ADDENDUM No. 1

RFP No. 23-04

Broadway Street Water Main Replacement and Resurfacing Project

Z:\2021\211210\CAD\CD\211210_details.dwg - Plot Date: 1/13/2023 2:24:17 PM

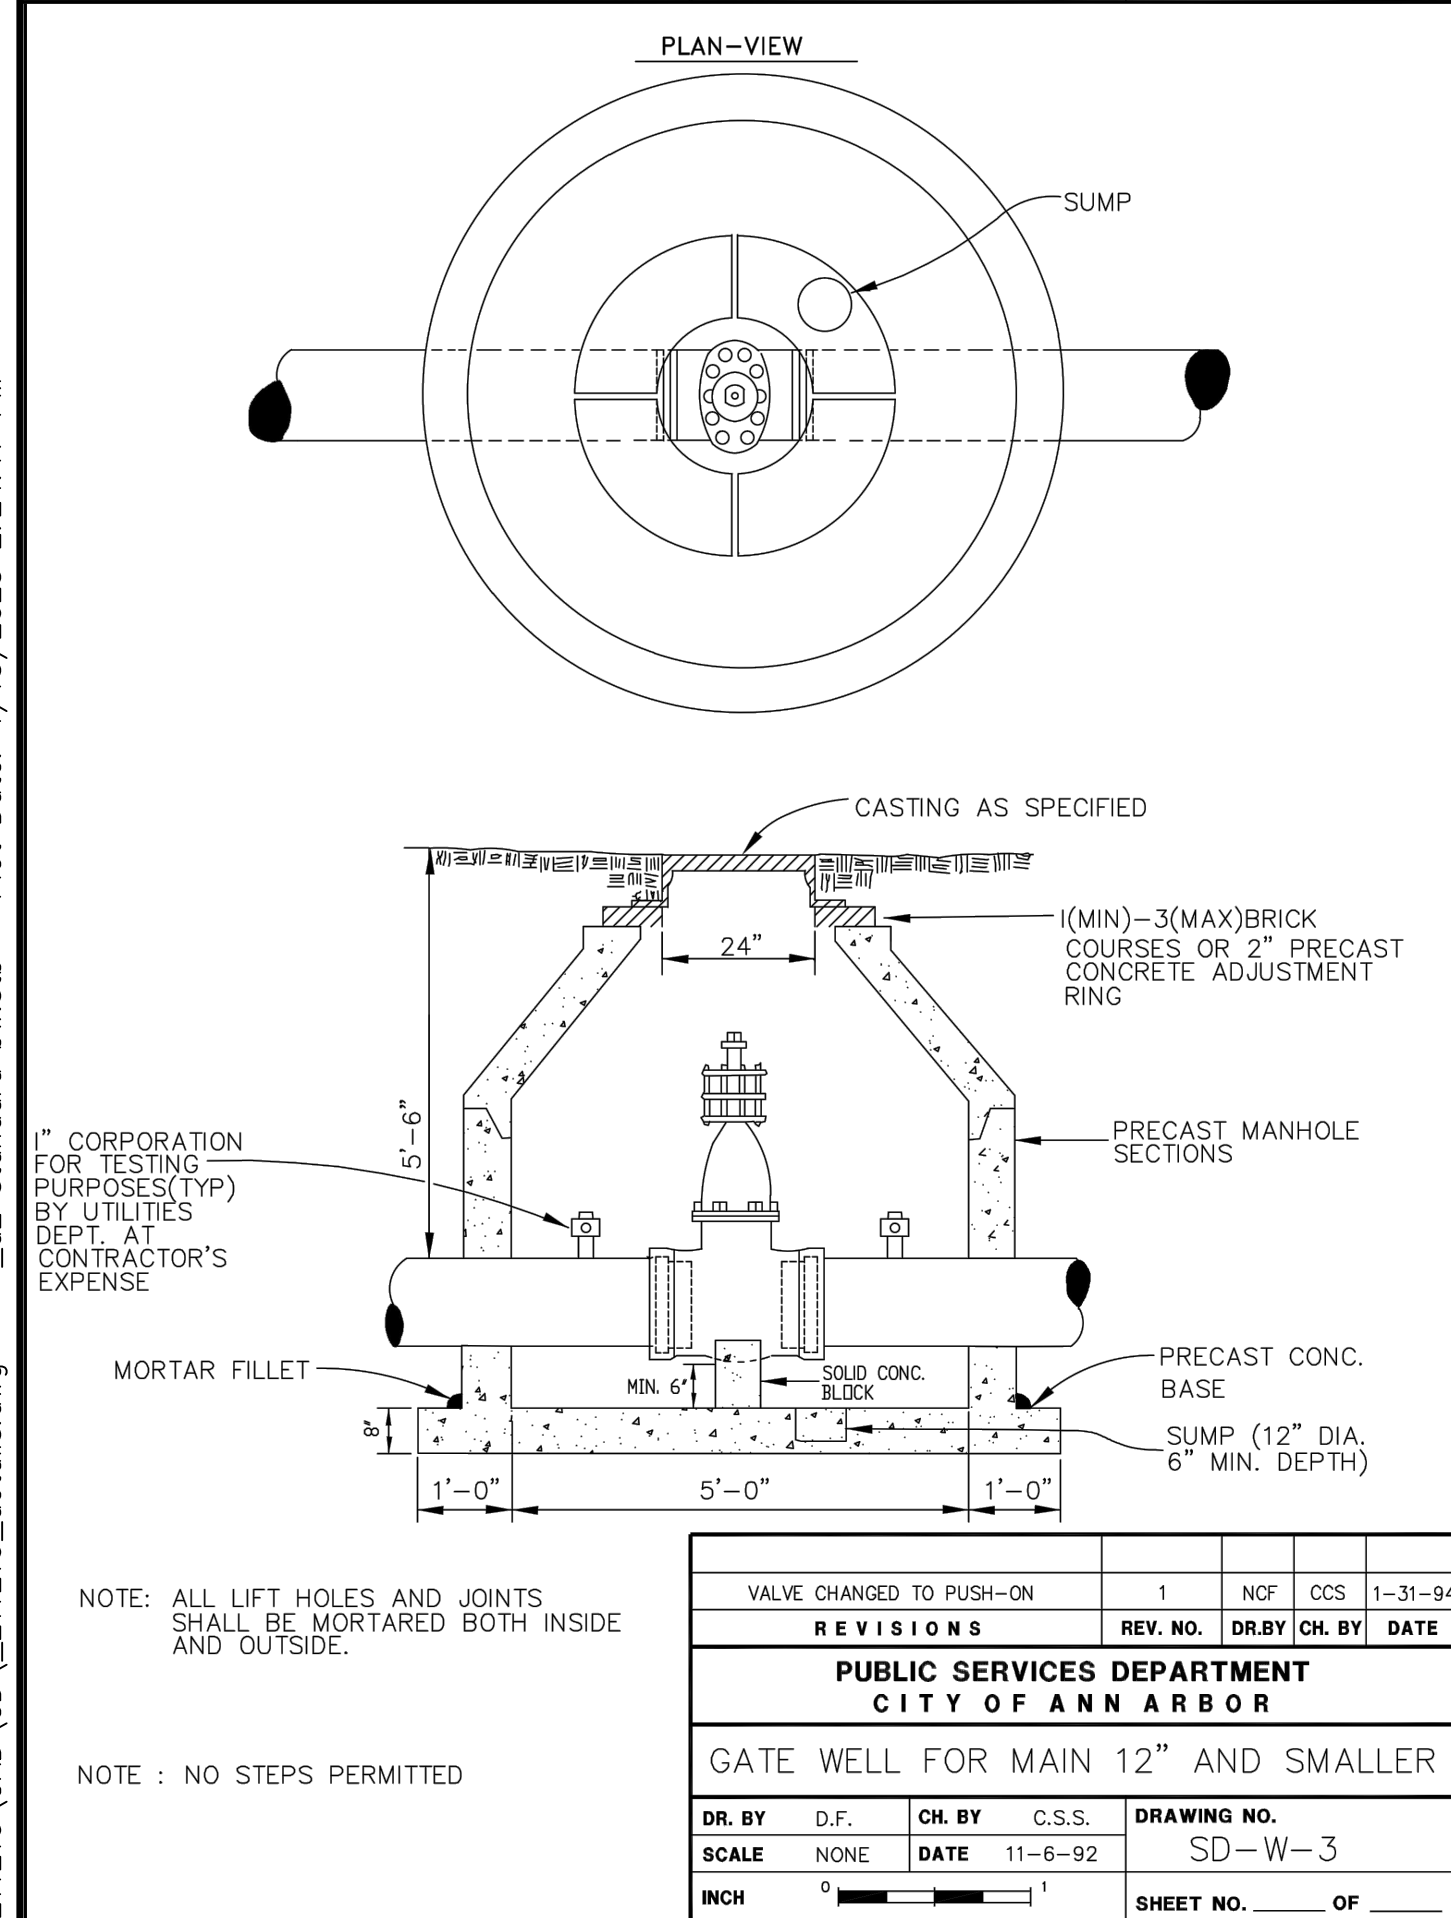
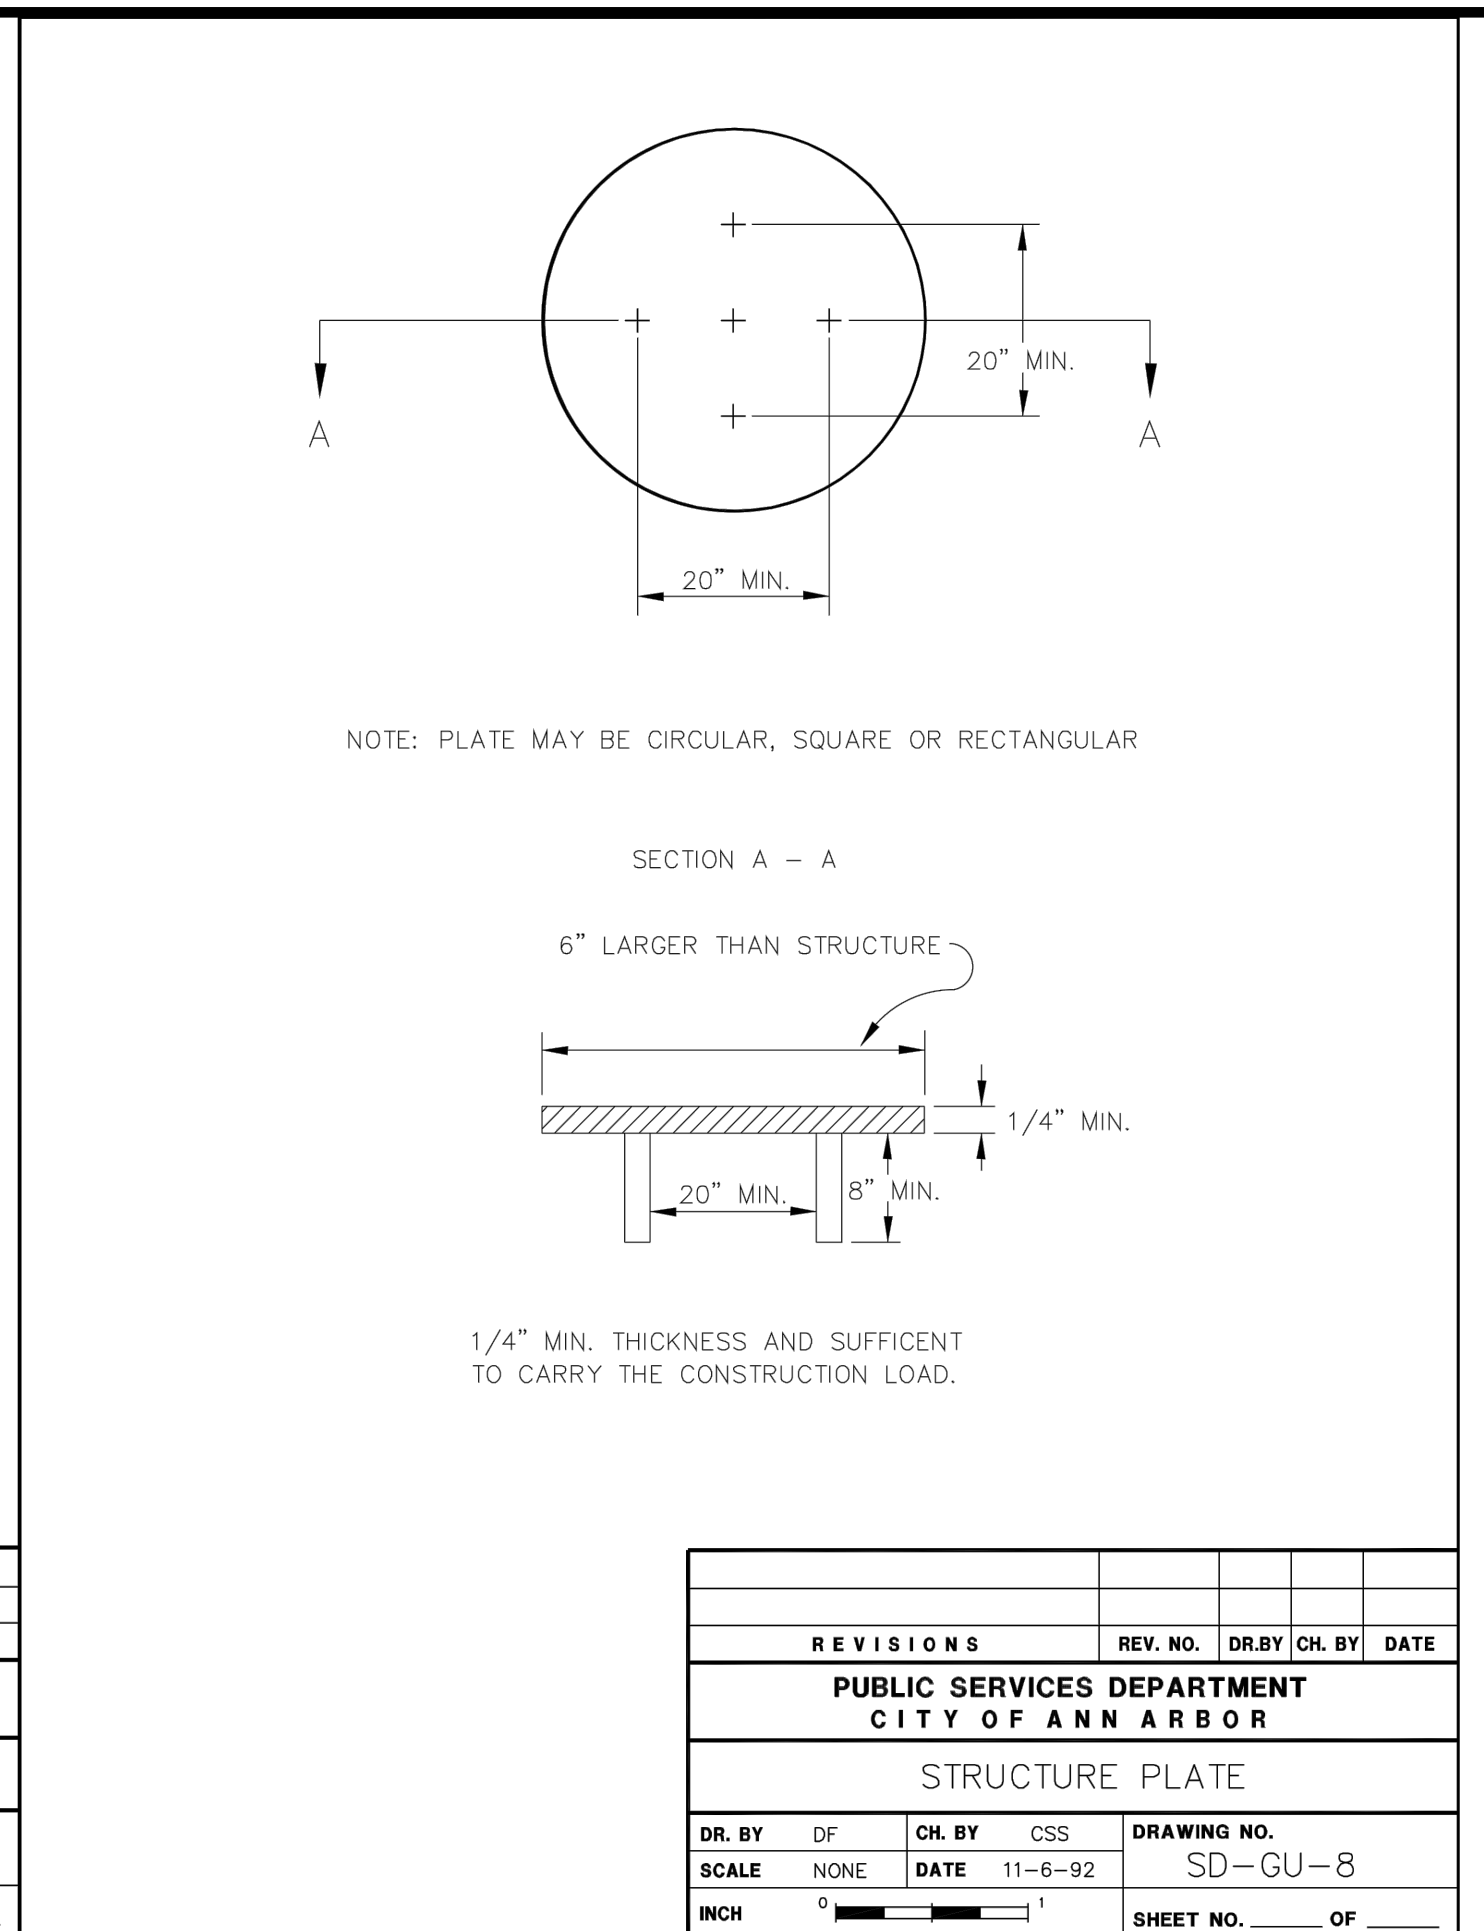
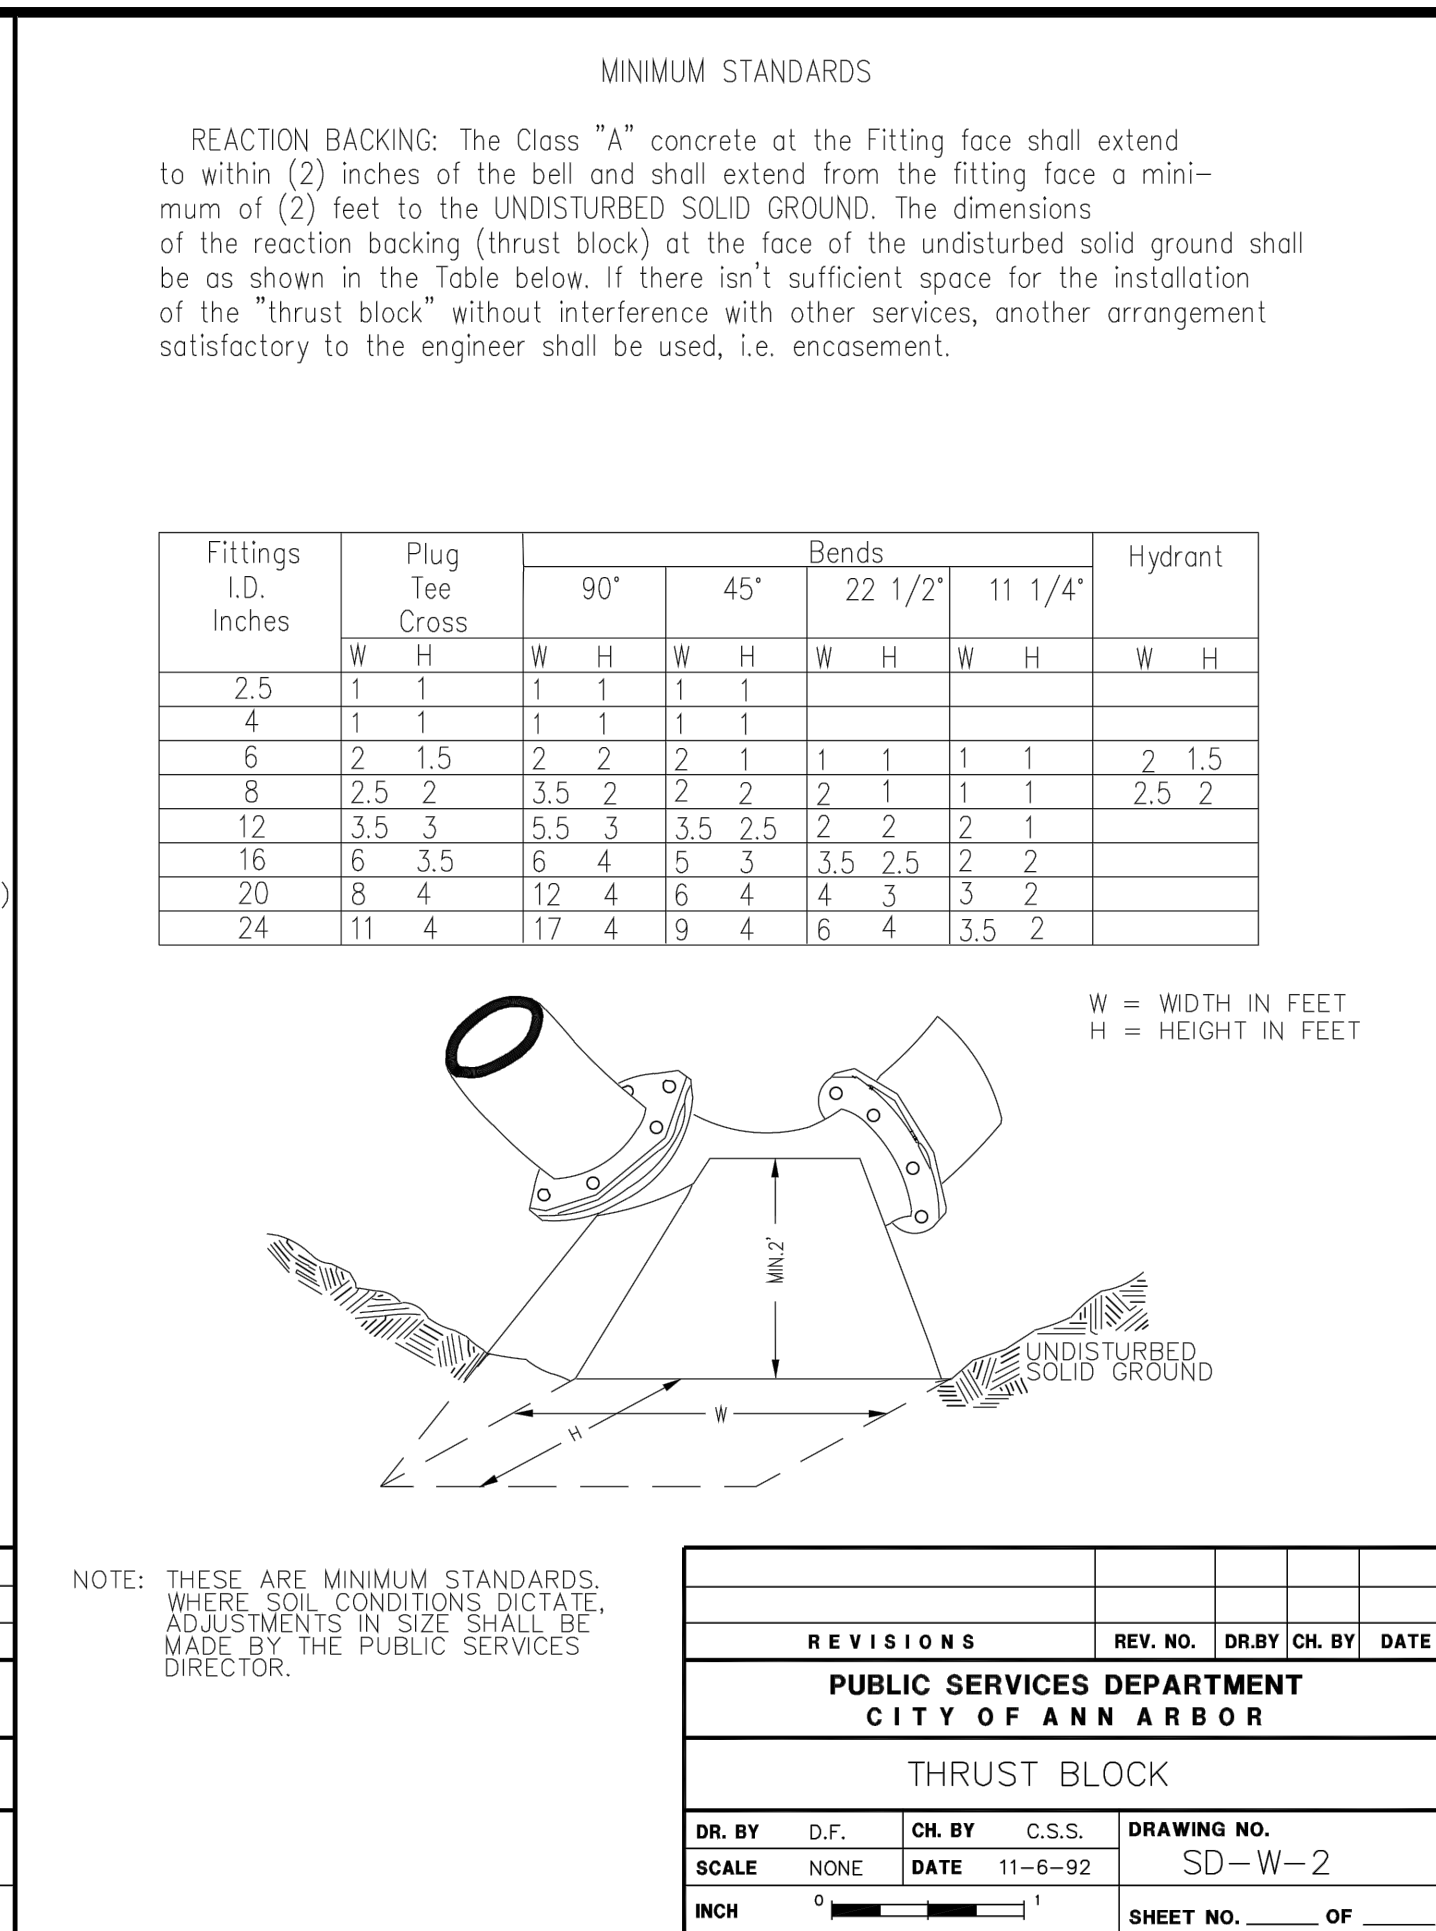
Section/Page(s)	Change
Replace Plan Sheets 11-12	Revised Standard details.
Replace Plan Sheets 15-18	Revised sheets to include catch basins and storm leads Revised sheets to include update location of exiting gas main.
Replace Plan Sheets 31-35, 37, 39-41	Revised sheets to include catch basins and storm leads Revised sheets to include update location of exiting gas main. Revised sheets to include structure and sewer table
